TECHNICAL NOTE

Bureau of Land Management U. S. DEPARTMENT OF THE INTERIOR

Subject: ANTI-DIESELING SOLENOID
 BRACKET BREAKAGE - 1968
 CHEVROLET W/L-6 ENGINE

Subject: ENGINE DIESELING - 1968 PASSENGER
 AND TRUCK WITH L-6 ENGINE

FIGURE 1

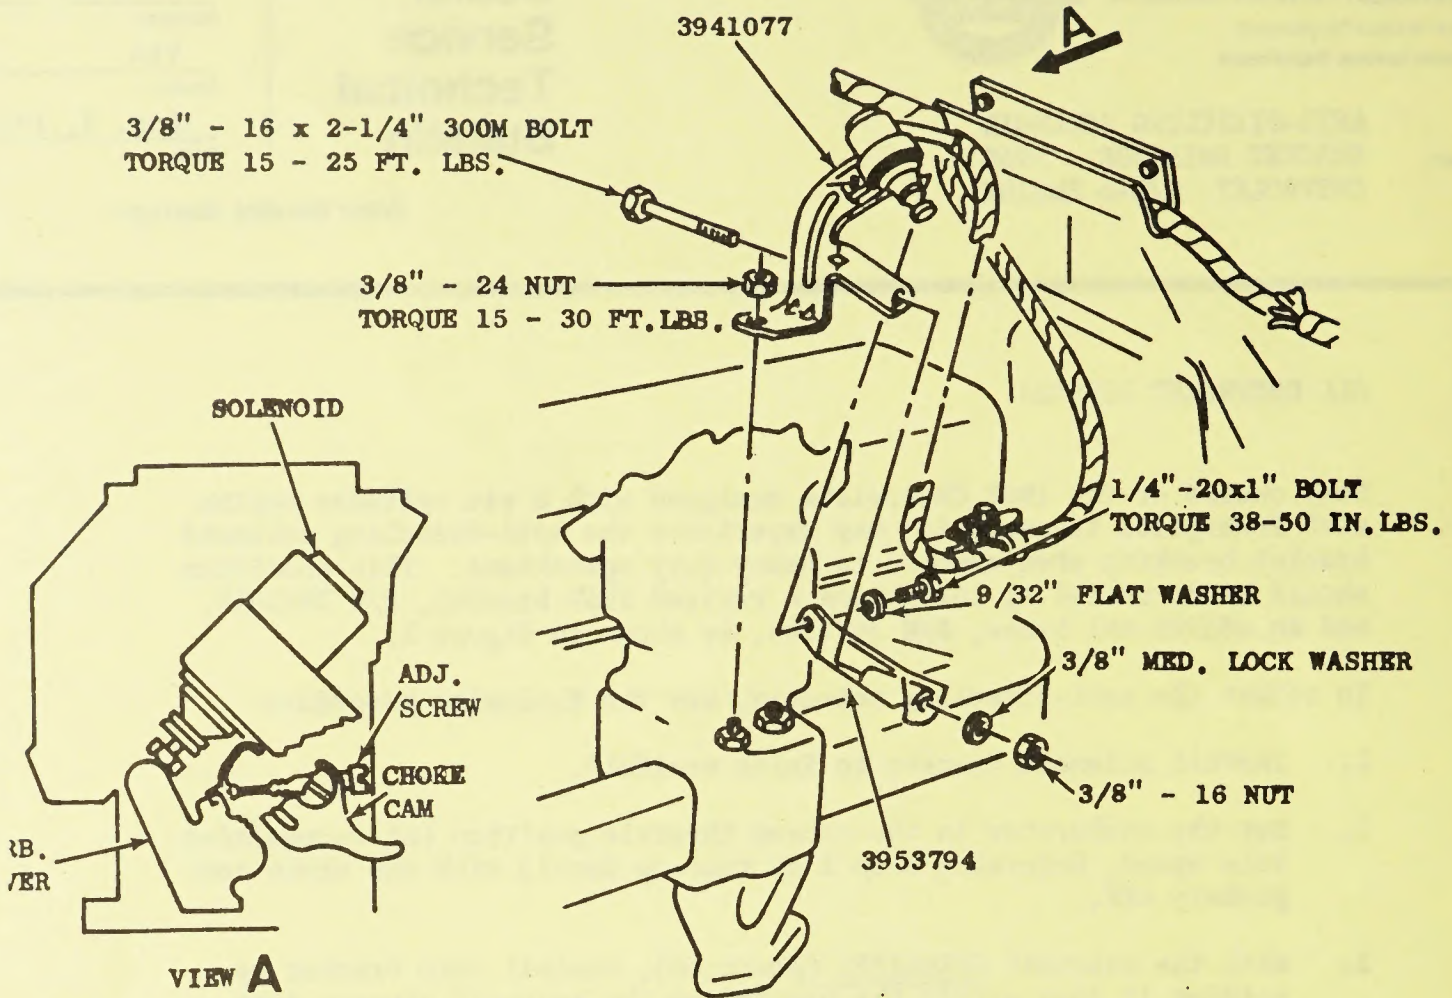
Some owners of the 1968 Chevrolets equipped with a six cylinder engine with Powerglide transmission may experience the anti-dieseling solenoid bracket breaking when exposed to heavy duty operations. This condition should be corrected by installing a revised 1969 bracket, P/N 3941077, and an additional brace, P/N 3953794, as shown in Figure 1.

To adjust the anti-dieseling solenoid, use the following procedure:

1. Install solenoid bracket to inlet manifold.
2. Set the carburetor in the closed throttle position (at recommended idle speed, Reference Step 1 on tune-up decal) with the choke completely off.
3. With the solenoid ENERGIZED (power on), install into bracket by sliding it down within the bracket so the solenoid plunger just slightly contacts the carburetor lever. Tighten the bracket strap to secure the solenoid in place.
4. Back carburetor idle adjusting screw out 3/4 turn (counter-clockwise). This results in a clearance between the carburetor idle adjusting screw and its stop on the lever of approximately .025".

NOTE: The above adjustment should produce an engine idle speed of approximately 400 RPM when the solenoid is DE-ENERGIZED (power removed).

6 CYLINDER SOLENOID WIRING
CHEVROLET

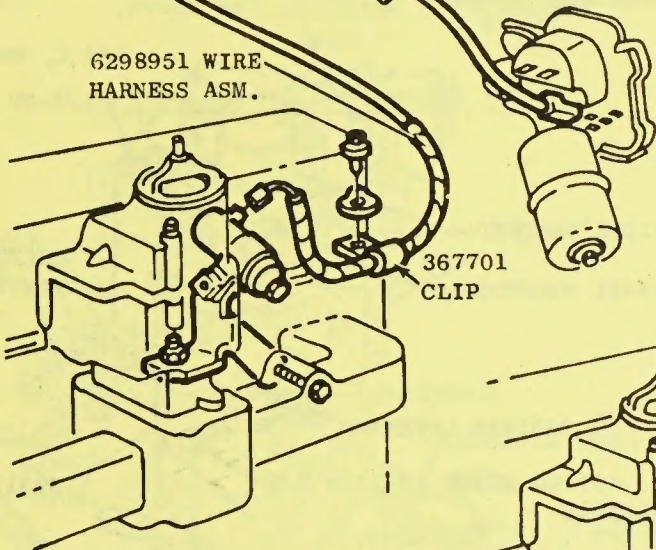
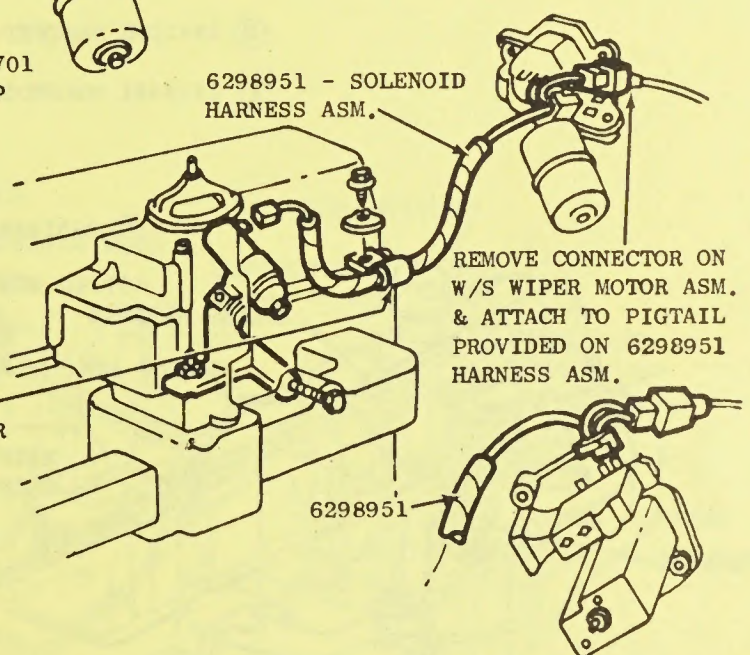
The engine anti-dieseling solenoid installation procedure on the L-6 passenger car has been revised to connect the solenoid wire to the ignition terminal of the fuse panel and not to the windshield wiper motor terminal as shown on Page 3 of the original bulletin.

This change is necessary, for after the ignition key is turned off, there may be sufficient current feed-back in the wiper motor circuit to hold the solenoid plunger in the fast idle position (engine dieseling).

The revised L-6 passenger car solenoid wire installation procedure is the same as shown on Page 4 of the original bulletin titled Wire Assembly To Dash Panel (Truck) except the passenger car installation requires drilling a 3/4" diameter hole in the dash panel. The grommet that is part of the 3942886 truck wire assembly should be positioned on the wire to provide the length needed to reach the ignition terminal of the fuse panel.

Any excess wire should be taped back to assure that no interference exists in the area of the accelerator brake or clutch linkage.
